# Camden Council

**Ordinary Council Meeting**  
**12 February 2013**

**SUBJECT:** SECTION 96(2) MODIFICATION APPLICATION - MODIFICATIONS TO APPROVED CEMETERY

**PROPOSAL:** Section 96(2) Modification Application – Modifications to approved cemetery works

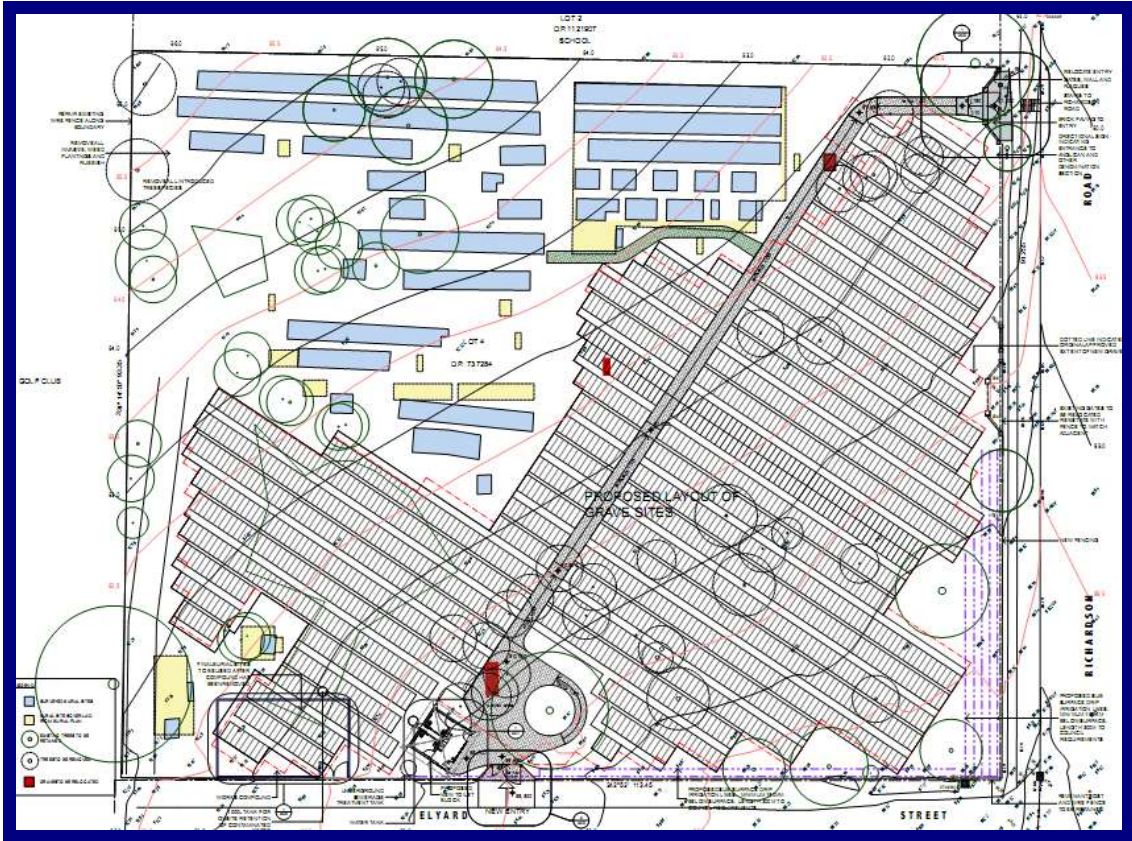
- deletion of the originally approved access path along the northern boundary of the site and provision of an alternative access path through the middle of the site. The location of the alternative access path is shown in green on the site layout plan provided below;
- removal of the requirement to retain and propagate the two existing *pimelia spicata* plants on the site and replacement with a requirement to maintain undisturbed areas of the site so that the plant may generate naturally;
- the retention of the requirement to provide interpretative signage on the site and to consult with the Friends of Narellan cemetery to inform the wording of the signage;

- realignment of the central access path approximately 8m to the west to ensure disabled access throughout the site (including compliant ramp lengths at the Richardson Road and Elyard Street entries);

- modification of the staging of burial plots, due to the access requirements listed above. The modified staging is shown on the amended staging plan provided below;

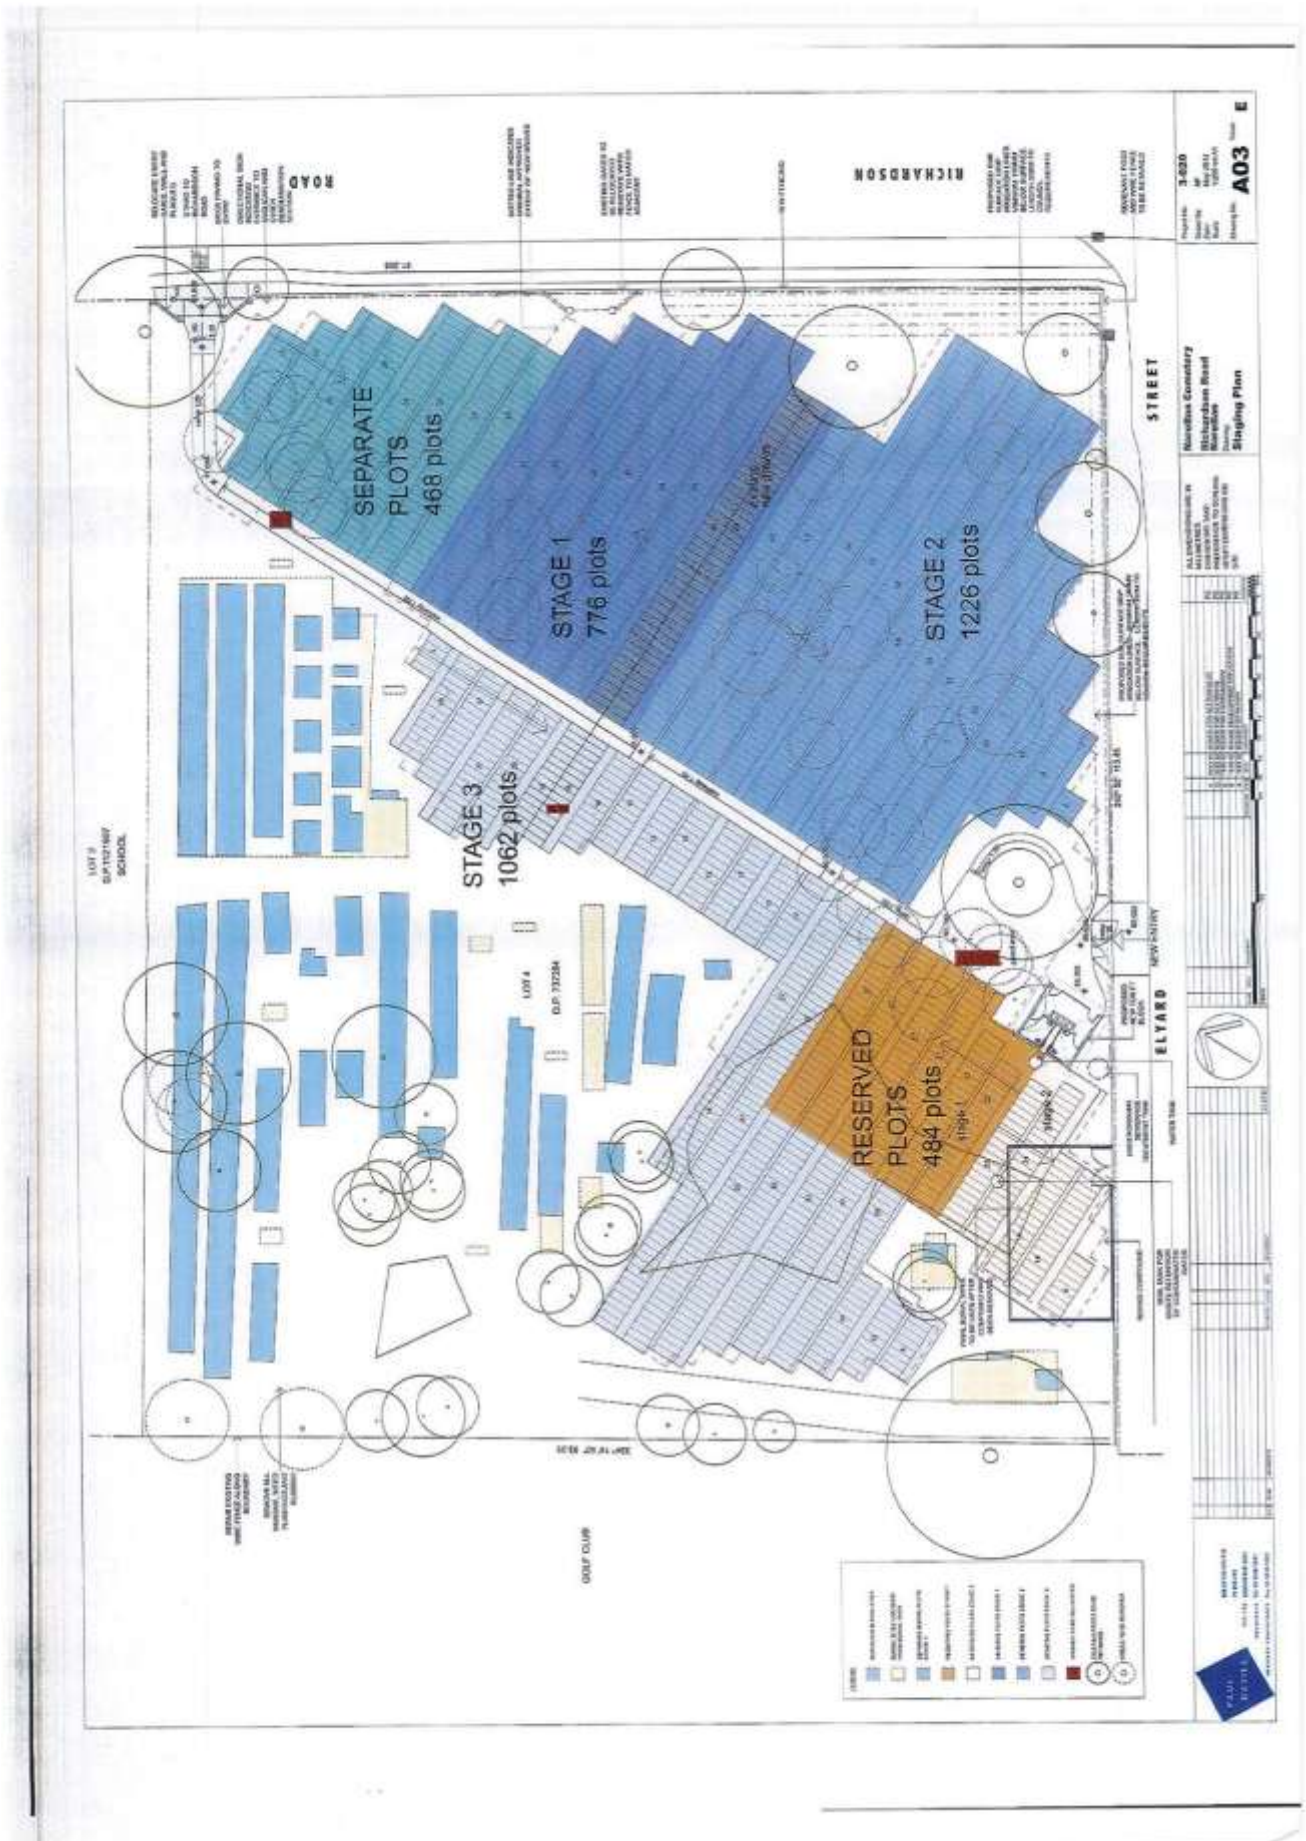
- modification of the grave layout including the addition of an access path between each row of graves. This will result in a reduction in the total number of graves from 4,846 to 4,016 (830 less graves, which is a reduction of 17%);

- relocation of the Elyard Street entry gate approximately 4.5m to the west in order to provide more efficient entry to the realigned central access path and amenities building;

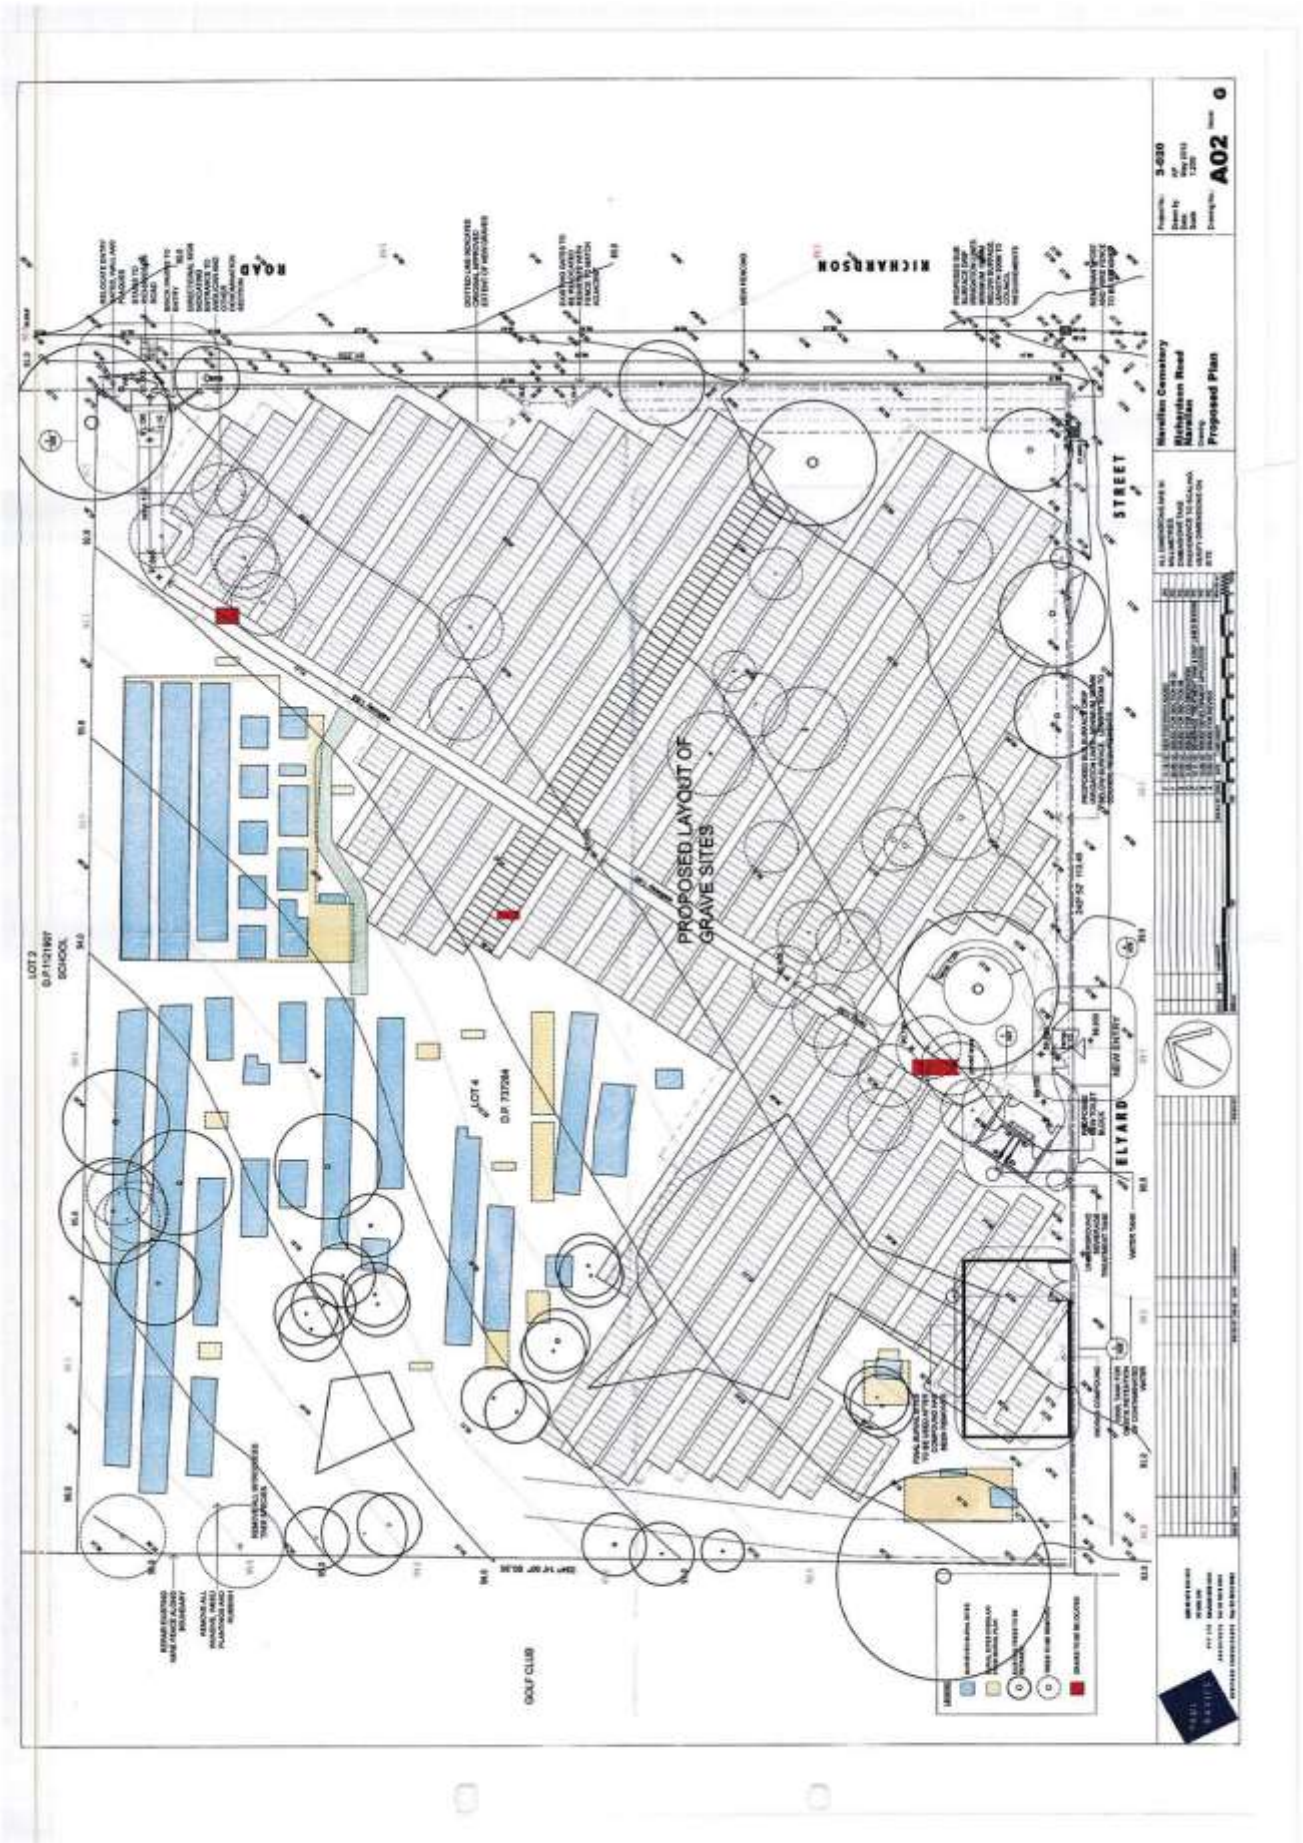
The applicant has confirmed that there is no intention to relocate plots V44, V45 and V46, which are located in the last stage of the cemetery's development. The proposed restaging plan does not indicate any new graves or landscaping in the vicinity of the Friend family's graves which would impede access to them.
